# SERVICE BULLETIN No. 292 79 2230

**Subject:**  
Oil system - Improvement of the oil pump sealing.  
Modification TU 230.

APPLICABLE ENGINE / VARIANT(S)	EFFECTIVITY CODE	MAINTENANCE LEVEL	CONDITION OF APPLICATION	OPERATIONAL EFFECT
ARRIEL 2 B, B1, B1A, C, C-PM, C1, C2, C2-CG, D, E, H, N, S1, S2	2-C-2	1, 2, 3	Application upon customer request	Removal/installation of the oil pump
		4	Application if replacement (discard) of the cover or bottom of the pump

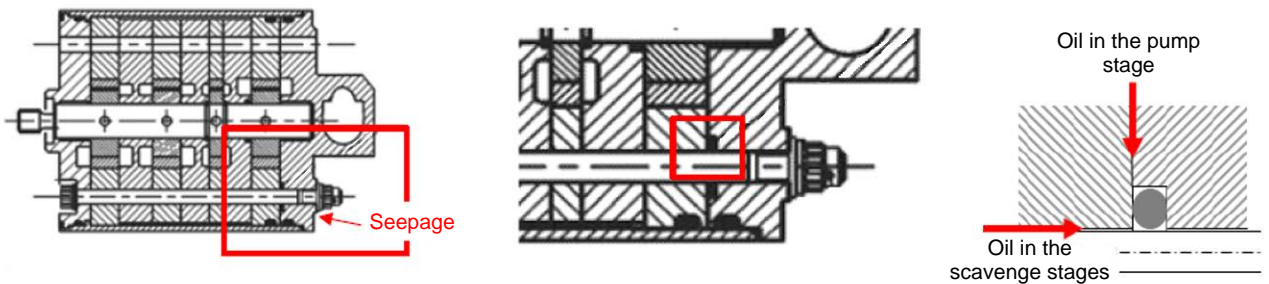
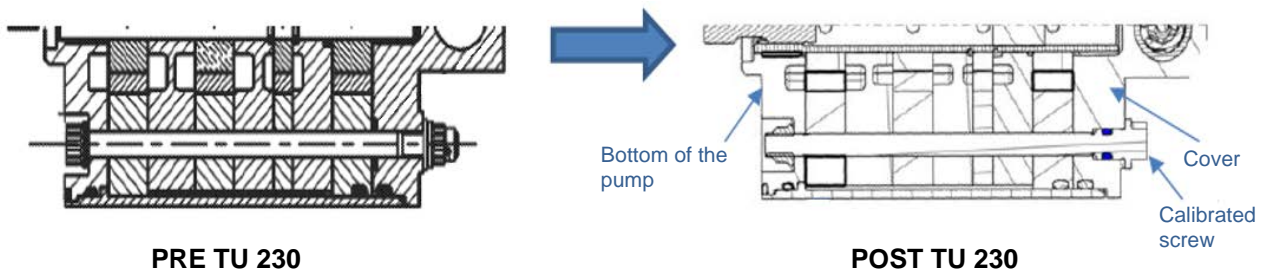
An integrator customer found oil seepage coming from the ARRIEL 2 oil pumps.

The seal on the calibrated screws of the oil pumps is in an axial sealing configuration.

This seal elongates radial sealing when this seal is positioned on the calibrated screw.

Tests showed that it is possible that this elongation is not sufficient and that it can cause oil seepage.

Modification TU 230 is a change in the sealing design of the calibrated screws, as the seal groove housing is now on the screw. The cover and the bottom of the pump are fitted as necessary.

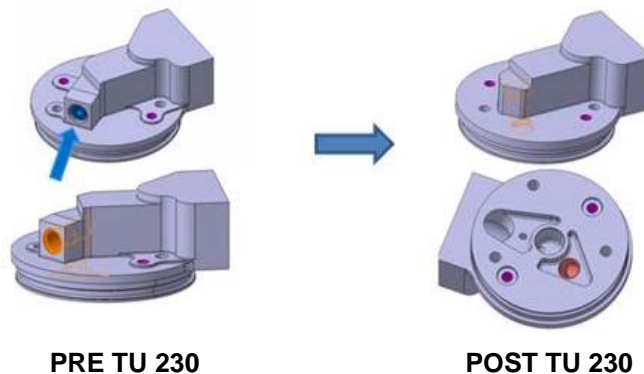
In addition, the cover is changed and then a plug is no more necessary (and this prevents possible seepage).
